SERVICE BULLETIN

NUMBER: 24-119

SUBJECT: REWORK OF COWL FLAPS

MODELS
AFFECTED: M20J S/N 24-0001 thru 24-0763 - Hinge Modification
M20J S/N 24-0001 thru 24-0854 - Doubler Modification

FIGURE 1

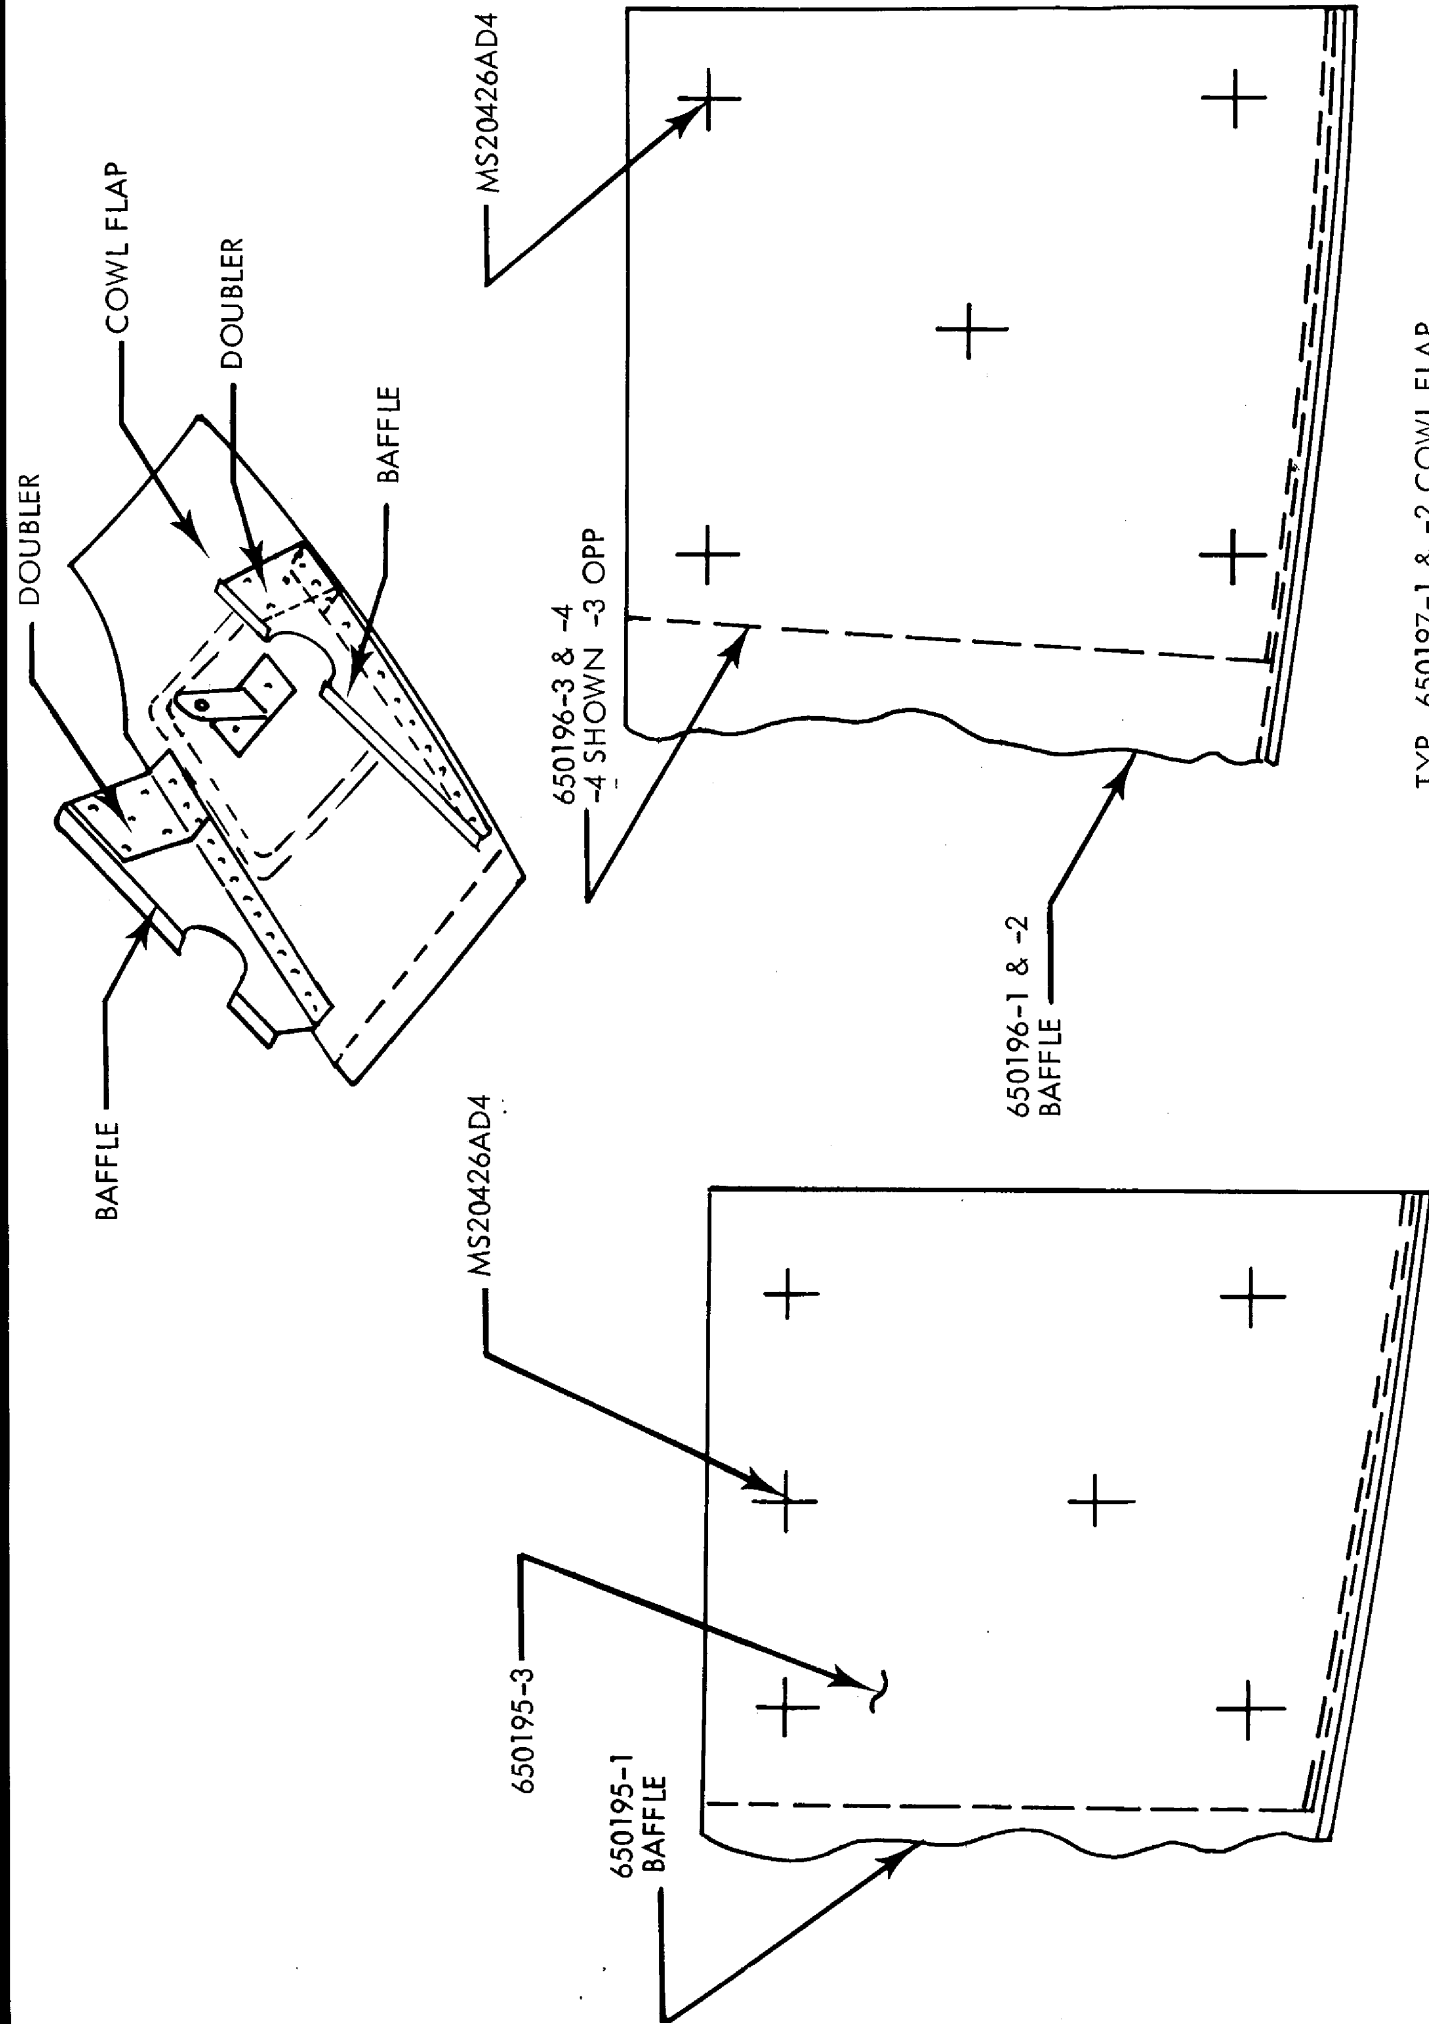
INTRODUCTION: Instances of cowl flap hinge points and cowl flap baffle plates cracking in service have been reported. The castellated nuts do not allow a uniform torque to be administered at installation. This Service Bulletin modifies this attach point and strengthens the baffle by adding a doubler.

- INSTRUCTIONS:
- 1) Remove lower cowling from aircraft per Service Manual, Paragraph 3-1, disconnecting all electrical and mechanical connections.
 - 2) Remove both cowl flaps from lower section of engine cowl.
 - 3) Drill out rivets and remove shim plate NAS463W10 (4 places) from all cowl flap baffles at hinge attach points (Ref. Figure 1).
 - 4) Install plate nut MS21047L3 (4 places) using (2) MS20426AD3 rivets at each location on all cowl flap baffles. (Ref. Figure 1).
 - 5) Drill or ream holes in cowl flap hinges (650193, 650198) (4 places) to a diameter of .313/.317 inches to accept bushing P/N 914090-1. This completes the hinge point modification.
 - 6) Carefully drill out the aft three (3) rivets that partially attach the baffles, P/N 650195-1 and 650196-1, -2 to the cowl flaps (Ref. Figure 2). (Part number 650195-2 is a short baffle and does not require a doubler).

- 7) Reassemble the modified cowl flaps to the engine cowls (Reference Figure 1) using the bolts, nuts and bushings included in this kit. Torque the AN3-5A bolts (4 places) to 15-20 inch pounds.
- 8) Reassemble the lower engine cowl to the aircraft per Service Manual and rig the cowl flaps per Paragraph 3-24 of Service Manual.
- 9) Make entry of compliance into Aircraft Log Book and fill out the enclosed compliance card and return to: Customer Service, Mooney Aircraft Corporation, P.O. Box 72, Kerrville, TX 78028.
